CAR RADIO DIVISION, ELECTRONIC INDUSTRIES LTD.

SERVICE DATA

MODELS C20J and C24J

PROCEDURE FOR CHANGING POLARITY OF BATTERY CONNECTION

PB 1663

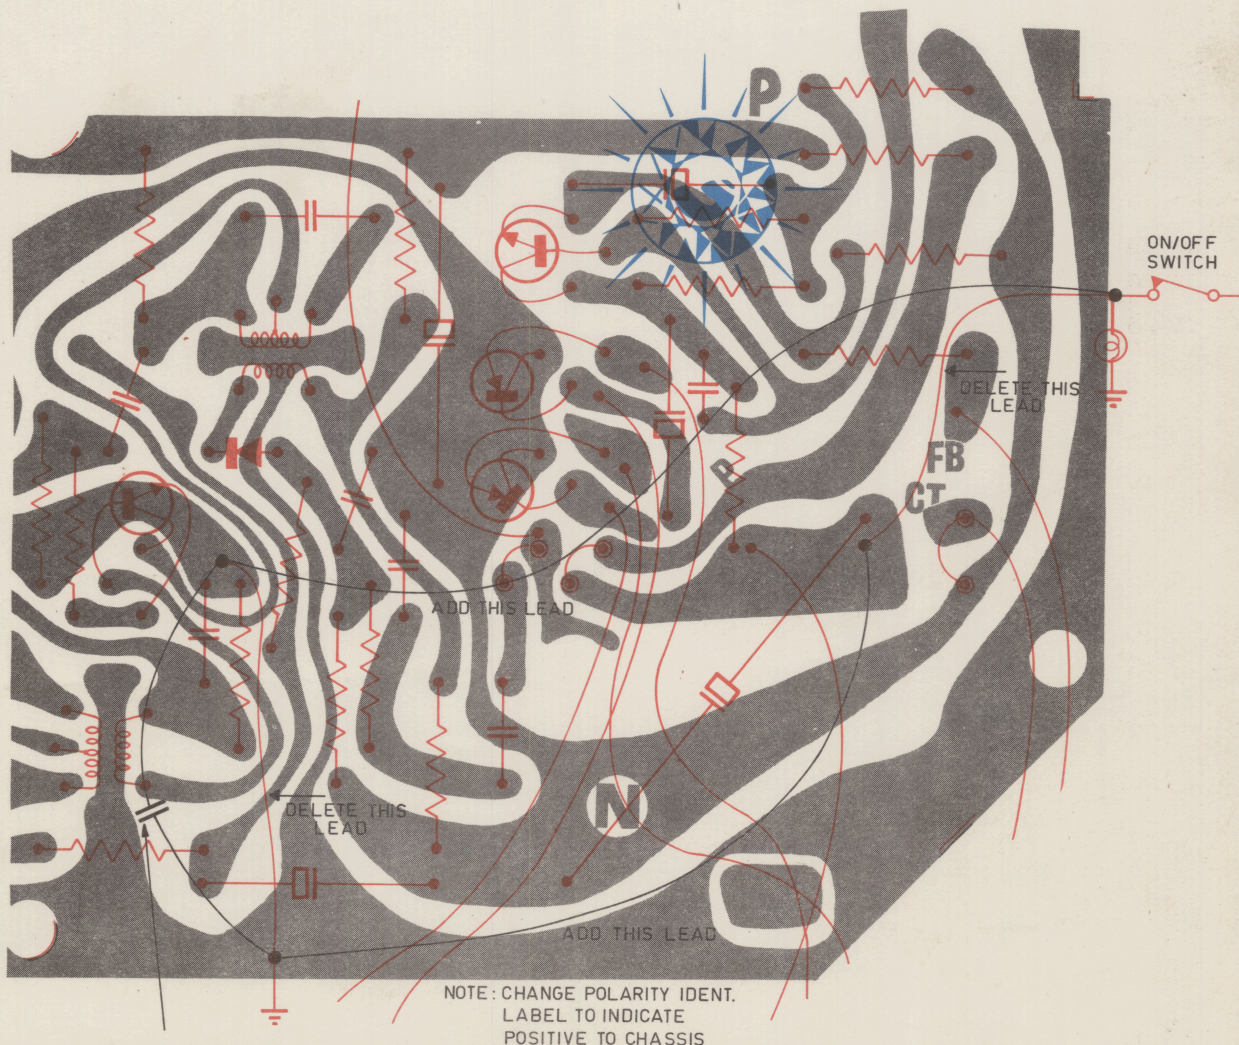
These receivers are manufactured for 'Negative to Chassis' operation. To change the polarity to 'Positive to Chassis' condition the following procedure must be performed.

ADD THIS CAPACITOR
-47 μ F 10% 160V DCW
POLYESTER PART No. 4009-003-09
